LAYOUT OF HOUSE SITES IN S.No: 382/2 OF KOLAPAKKAM VILLAGE.

P.P.D NO: 48
 L.O 2019

VIDE LETTER NO : L1 / 1048 / 2019
 DATE : 15 / 04 / 2019

FOR SENIOR PLANNER (MSB)
 CHENNAI METROPOLITAN
 DEVELOPMENT AUTHORITY

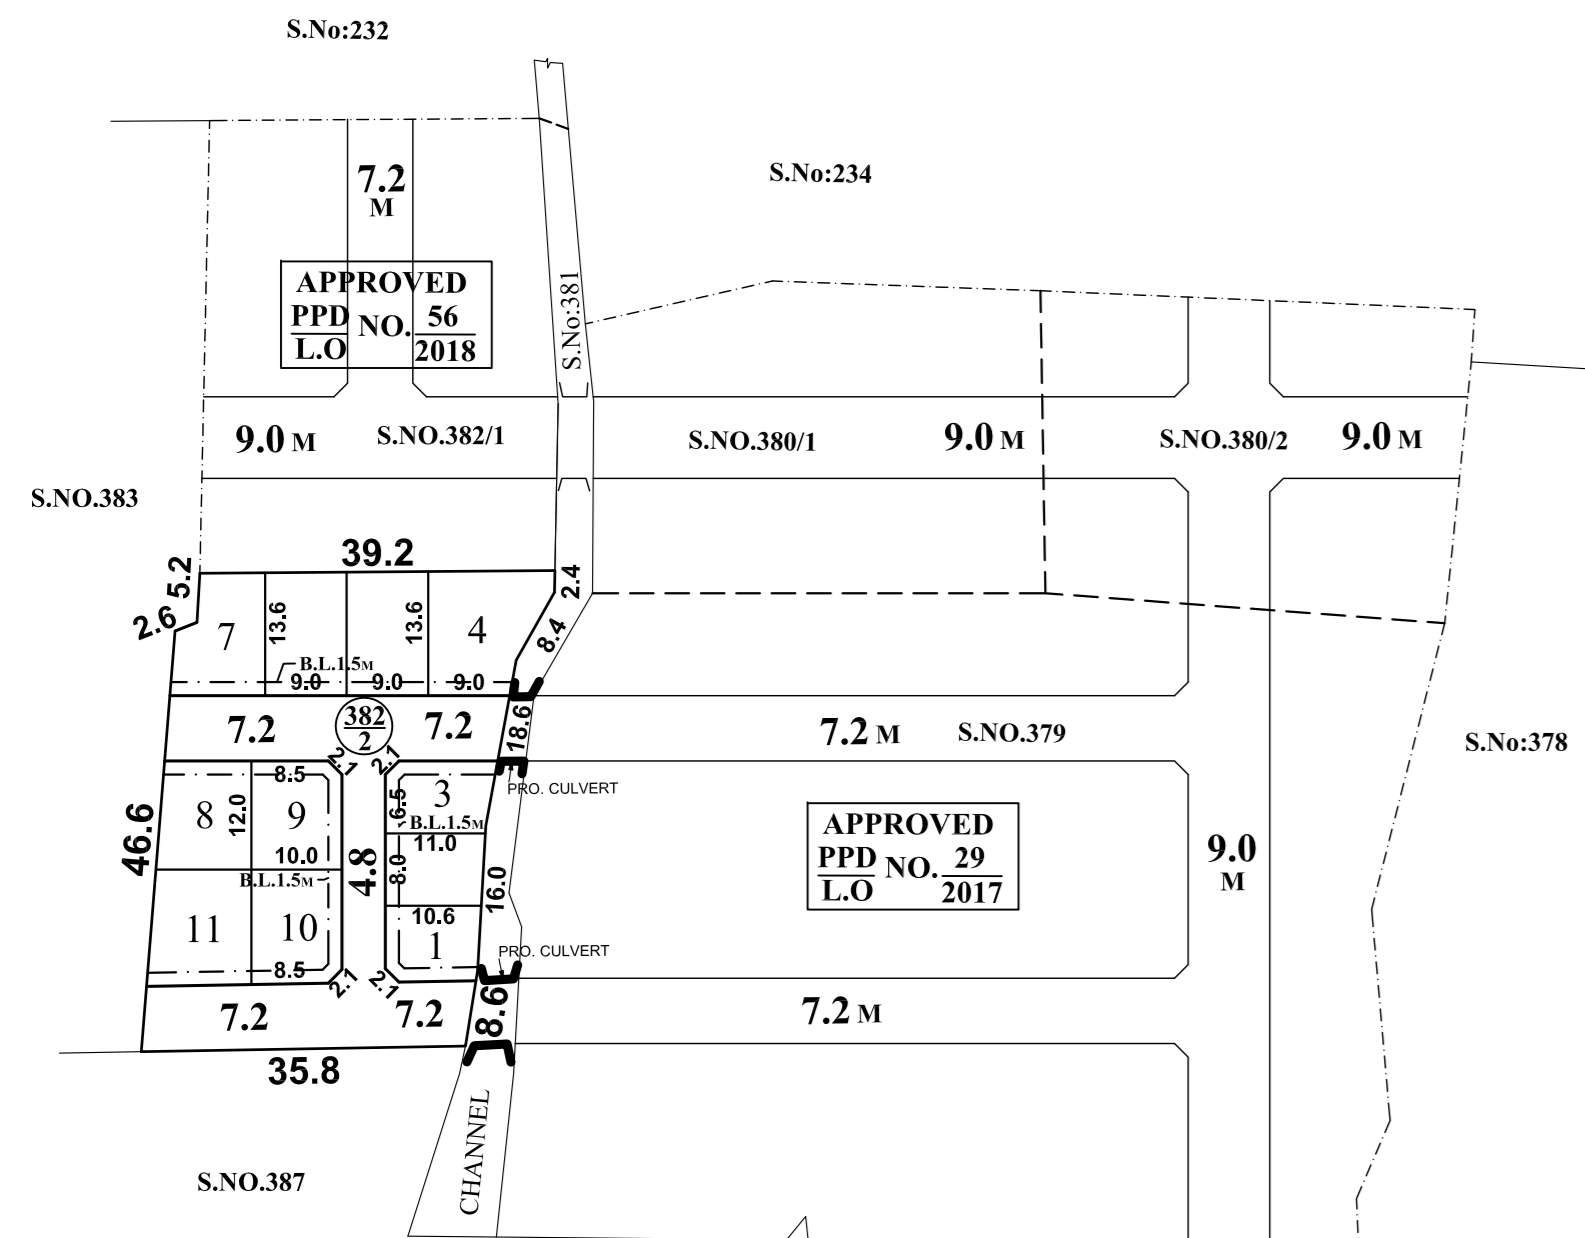
- THE FOLLOWING CONDITIONS OF PWD VIDE CE, PWD/WRD, CHENNAI REGION, CHEPAUK, CHENNAI-5, LETTER NO: DB/T5(3)/F-CULVERT-KOLAPAKKAM/2018 DT:24.09.2018 ARE TO BE COMPLIED BY THE APPLICANT BEFORE SANCTION OF THE LAYOUT.

- THE PROPOSED RCC BOX CULVERT-2 NOS. OF SIZE & IN S.F.NO.381 SHOULD BE CONSTRUCTED ACROSS THE CHANNEL ON EASTERN SIDE OF THE APPLICANT'S LANDS AS EARMARKED IN THE SKETCH FOR TEMPORARY OCCUPATION FOR THREE YEARS FROM THE DATE OF AGREEMENT. THE WIDTH OF THE CHANNEL EARMARKED IN THE FMB SKETCH SHOULD BE MAINTAINED AS PER REVENUE RECORDS AND SHOULD BE MAINTAINED WITHOUT ENCRoACHMENT. ONLY IF THE APPLICANT'S LAND/ROAD AVAILABLE ON BOTH SIDES OF THE CHANNEL THIS PERMISSION IS ELIGIBLE FOR CONSTRUCTION OF CULVERT. THE APPLICANT SHOULD NOT CARRY OUT ANY OTHER CROSS MASONRY STRUCTURES ACROSS THE CHANNEL WITHOUT PRIOR PERMISSION FROM PWD/WRD. THE APPLICANT SHOULD PROVIDE A PUCCA CONCRETE BED IN THE CHANNEL AT THE PROPOSED CULVERT SITES WITHOUT FAIL. HOWEVER, IF THE CMDA INSISTS FOR ANY MORE CULVERTS DURING PLANNING APPROVAL, THE APPLICANT SHOULD APPROACH THE PWD/WRD FOR GETTING SEPARATE APPROVAL FOR ANY ADDITIONAL CULVERTS IN FUTURE.

- THE PROPOSED BOX CULVERT SHALL BE MADE UP OF RCC BOX TYPE WITH A MINIMUM VENT INNER SIZE, WIDTH AND HEIGHT FOR A CARRIAGE WIDTH ARE SPECIFIED BELOW SHOULD BE WELL WITHIN THE BOUNDARY. THE SIZE & SILL LEVEL OF THE PROPOSED RCC CULVERT SHOULD BE MAINTAINED AS MENTIONED BELOW IN THE SPECIFIED S.F.NO AND SHOULD BE GOT EXECUTED ONLY IN THE PRESENCE OF PWD/WRD OFFICIALS. THE BED LEVEL OF THE CULVERT SHOULD BE FIXED IN PRESENCE OF THE EXECUTIVE ENGINEER CONCERNED ONLY AFTER THE EXISTING CHANNEL ORIGINAL BED LEVEL ASCERTAINED AND RESTORED FOR THE FLOW DIRECTION FROM ITS ORIGINATES. HYDRAULIC PARTICULARS RECOMMENDED FOR CULVERT

BED LEVEL OF CHANNEL (EXISTING)	:	(+)-9.050M & (+)-9.060M
PROPOSED SILL LEVEL	:	(+)-8.465M & (+)-8.435M
PROPOSED FSL INCLUDING FREE BOARD	:	(+)-10.320M
BOTTOM OF DECK SLAB OF PROPOSED CULVERT	:	(+)-10.320M
OBSERVED MFL, NEAR SITE DURING DEC 2015	:	(+)-9.630M
NEAREST VILLAGE ROAD TOP LEVEL	:	(+)-10.020M

- BASED ON THE HYDRAULIC PARTICULARS MENTIONED ABOVE, THE DESIGN AND DRAWINGS OF THE PROPOSED RCC BOX TYPE CULVERT SHOULD BE OBTAINED FROM THE QUALIFIED STRUCTURAL DESIGN ENGINEER AND THE SAME SHOULD BE SUBMITTED TO THE EXECUTIVE ENGINEER, PWD., WRD., KOSASTHALAIYAR BASIN DIVISION, THIRUVALLUR FOR GETTING APPROVAL BEFORE THE COMMENCEMENT OF WORK. THE WORK SCHEDULE FOR THE ABOVE PROPOSAL SHOULD BE INFORMED TO THE EXECUTIVE ENGINEER, PWD., WRD., KOSASTHALAIYAR BASIN DIVISION, THIRUVALLUR FOR MONITORING AND ALSO COMPLETION OF CULVERT SHOULD BE REPORTED TO THE EXECUTIVE ENGINEER.

- THE CHANNELS IN S.F.NO.381 ALONG THE BOUNDARY OF APPLICANTS LAND SHOULD BE COMPLETELY DESILTED AND RESECTIONED BY CONSTRUCTING RETAINING WALL ON EITHER SIDE AS WELL AS BED LINING CONCRETE OF THE CHANNEL AS PER THE FMB AT THE APPLICANT'S OWN COST. THE BED LEVEL OF THE ABOVE CHANNEL SHOULD BE ASCERTAINED AND RESTORED BEFORE COMMENCING THE DEVELOPMENT ACTIVITY IN THE PRESENCE OF THE CONCERNED PWD/WRD EXECUTIVE ENGINEER. MOREOVER THE WIDTH OF ENTIRE FIELD CHANNEL AS PER REVENUE RECORDS (FMB) ALONG & WITHIN THE STRETCH OF APPLICANT'S LAND SHOULD BE MAINTAINED PROPERLY WITHOUT ANY CHANGE AND ENCRoACHMENT AT ANY COST.

- THE APPLICANT SHOULD CLEARLY DEMARCATATE HIS BOUNDARY ESPECIALLY ON THE EASTERN SIDE ABUTTING THE CHANNEL (S.F.NO.381) BEFORE THE COMMENCEMENT OF ANY DEVELOPMENTAL ACTIVITIES IN PRESENCE OF REVENUE AUTHORITIES AND PWD/WRD AUTHORITIES CONCERNED WITHOUT FAIL AND SHOULD NOT ENCRoACH THE CHANNEL ABUTTING THE LAND. THE NECESSARY SETBACK DISTANCE SHOULD BE PROVIDED AS PER THE NORMS IN EXISTENCE AND AS PER THE RULES IN FORCE OF CMDA.

- THE GOVERNMENT FIELD CHANNEL STRETCH ABUTTING THE APPLICANT BOUNDARY IN S.F.NO.381 SHOULD BE MARKED AS PER FMB AND MONITORED AND MAINTAINED BY THE APPLICANT AT THEIR OWN COST. THE WIDTH OF THE CHANNEL SHOULD BE MAINTAINED WITHOUT ENCRoACHMENT AS PER REVENUE RECORDS AND THE HYDRAULIC PARAMETERS OF THE FIELD CHANNEL SHOULD BE MAINTAINED. THE APPLICANT SHOULD MAKE NECESSARY PERIODICAL ARRANGEMENTS FOR FREE FLOW OF WATER THROUGH THE EXISTING CHANNEL TO THE DOWNSIDE AREA WITHIN THE PROPOSED LAYOUT SITE. ALSO THE APPLICANT SHOULD DE-SILT THE CHANNEL PERIODICALLY AND REMOVE THE OBSTRUCTION THEN AND THERE WITHOUT ANY HINDRANCE FOR FREE FLOW OF WATER AT THEIR OWN COST WITHIN THE PROPOSED LAND, AFTER THE COMPLETION OF PROJECT.

- THE PROPOSED RCC BOX CULVERT SHOULD BE MONITORED AND MAINTAINED FOR FREQUENT INSPECTION BY THE APPLICANT AT THEIR OWN COST. THE WIDTH OF THE CHANNEL SHOULD BE MAINTAINED WITHOUT ENCRoACHING AS PER REVENUE RECORDS AND SHOULD MAINTAIN THE HYDRAULIC PARAMETERS OF THE FIELD CHANNEL WITHOUT ANY CHANGE.

- THE ABUTEMENT, WING WALL, RETURN WALL, ETC., FOR EACH OF THE ABOVE PROPOSED CULVERTS SHOULD BE CONSTRUCTED WELL WITHIN THE APPLICANT'S LAND ON EITHER SIDE MOREOVER THE WIDTH OF FIELD CHANNEL AS PER REVENUE RECORDS (FMB) SHOULD BE MAINTAINED PROPERLY WITHOUT ANY CHANGE AT ANY COST.

- THE APPLICANT SHOULD DO PROPER SOIL TEST, AND SUITABLE FOUNDATION SHOULD BE SELECTED DEPENDING UPON THE SOIL CONDITION AND THE STRUCTURAL DESIGN SHOULD BE OBTAINED FROM THE APPROVED STRUCTURAL ENGINEER FOR CONSTRUCTION OF CULVERT.

- THE APPLICANT SHOULD PREPARE THE LAYOUT PROPOSAL BY CONSIDERING THE SUITABLE INTERNAL STORM WATER DRAINAGE NET WORK, RAINWATER HARVESTING AND SEWERAGE ALIGNMENT & GARBAGES/DEBRIS AND OTHER SOLID WASTE MANAGEMENT AS PER NORMS IN EXISTENCE WITHIN THE APPLICANT LAND ACCORDING TO THE EXISTING RULES IN FORCE AND SHOULD GET PROPER APPROVAL FROM THE COMPETENT AUTHORITY WITHOUT FAIL. THE SEWAGE OR ANY UNHYGIENIC DRAINAGE SHOULD NOT BE LET INTO THE FIELD CHANNEL AT ANY COST AND THE DEBRIS AND CONSTRUCTION MATERIALS SHOULD NOT BE DUMPED INTO THE CHANNEL IN ORDER TO AVOID FREE FLOW OF WATER.

- THE APPLICANTS LAND SHOULD BE FILLED WITH EARTH WITH PROPER COMPACTION TO THE MINIMUM LEVEL OF (+)-10.620M TO PROTECT THE SITE FROM INUNDATION DURING FLOODS. THE PROCESS OF EARTH FILLING AND COMPACTION SHOULD BE DONE IN LAYERS OF NOT MORE THAN 0.30M DEPTH TO ACHIEVE THE REQUIRED DEGREE OF COMPACTION FOR A DEPTH VARYING FROM 1.56M TO 1.67M DEPENDING UPON THE EXISTING FIELD LEVELS AND THE EXISTING APPLICANT LAND SHOULD BE RAISED TO A MINIMUM LEVEL OF (+)-10.620M AND 10.60M ABOVE THE EXISTING VILLAGE ROAD ABUTTING THE SITE AS (+)-10.020M. THE ALL-ROUND ENTIRE PAVEMENT LEVEL WITHIN THE SITE SHOULD NOT BE LESS THAN (+)-10.620M.
